PLAN 1

PLANNING APPLICATION PLN-21-0047

1 KING STREET, CRESSY

PLANNING APPLICATION Proposal

DRAWING	DRAINAGE PLAN
DATE	18/1/2020
DWG	536 SHEET 8 OF 12
SCALE	1:200

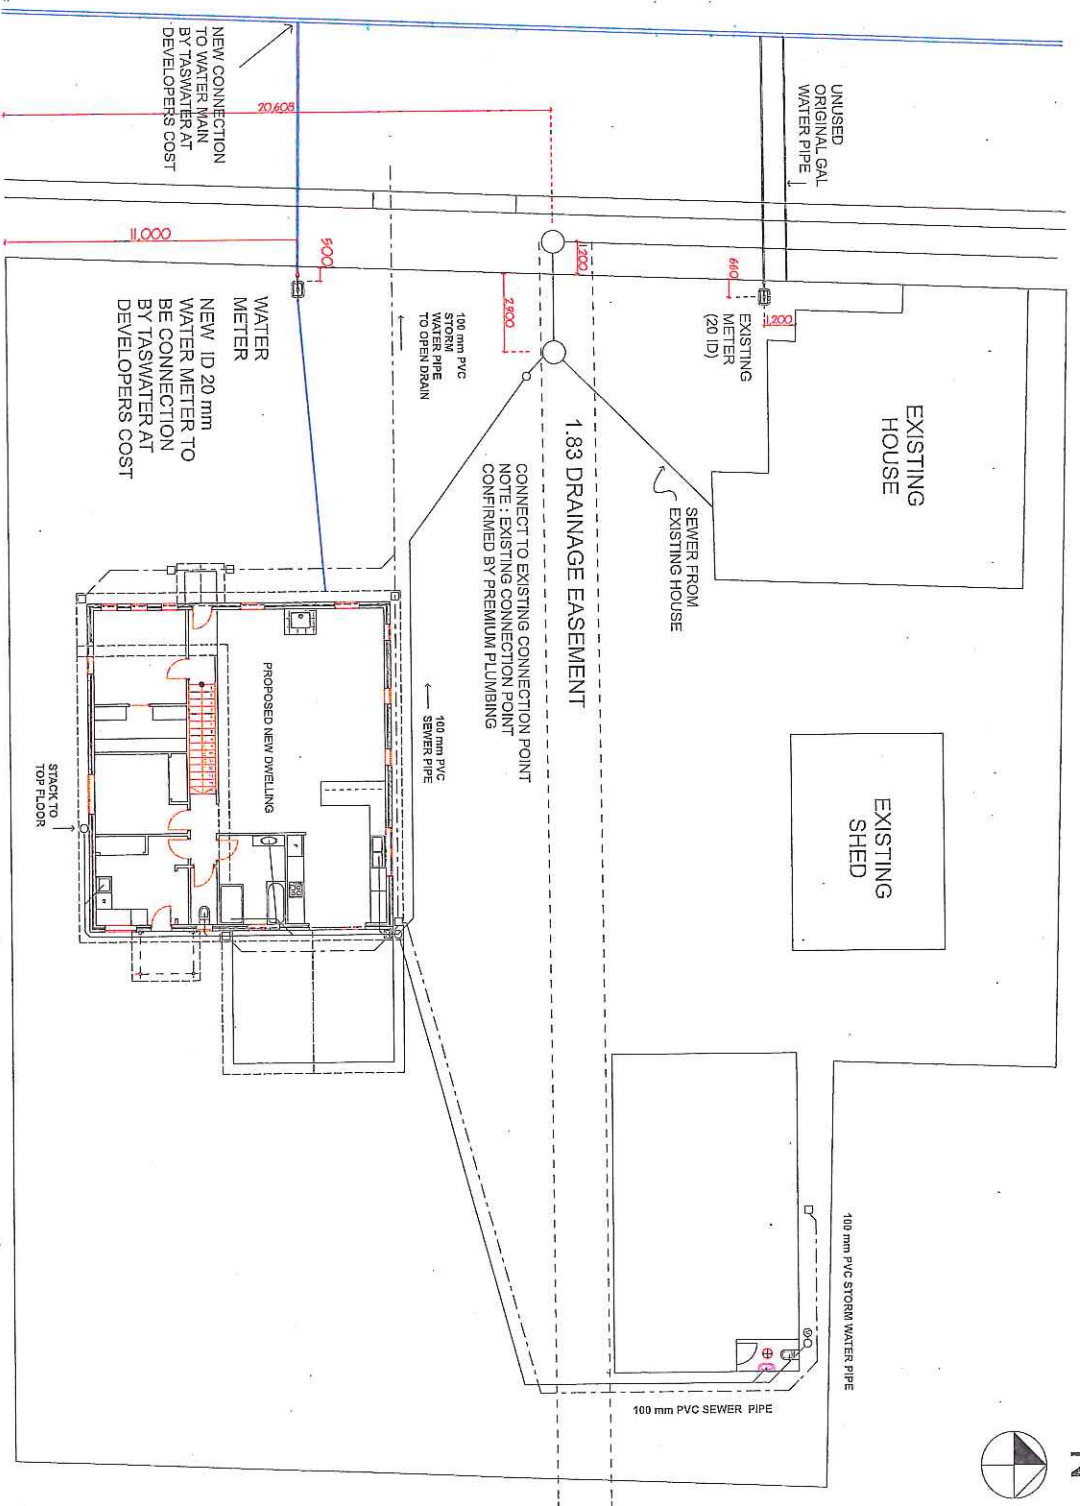
- (f) Existing water property connections that are being made redundant need to be shown to be cut and sealed by TasWater at developer's cost. Provide a note to this effect on the plans submitted at the CCW stage regarding the 'unused' water pipe shown on the Drainage Plan if required.
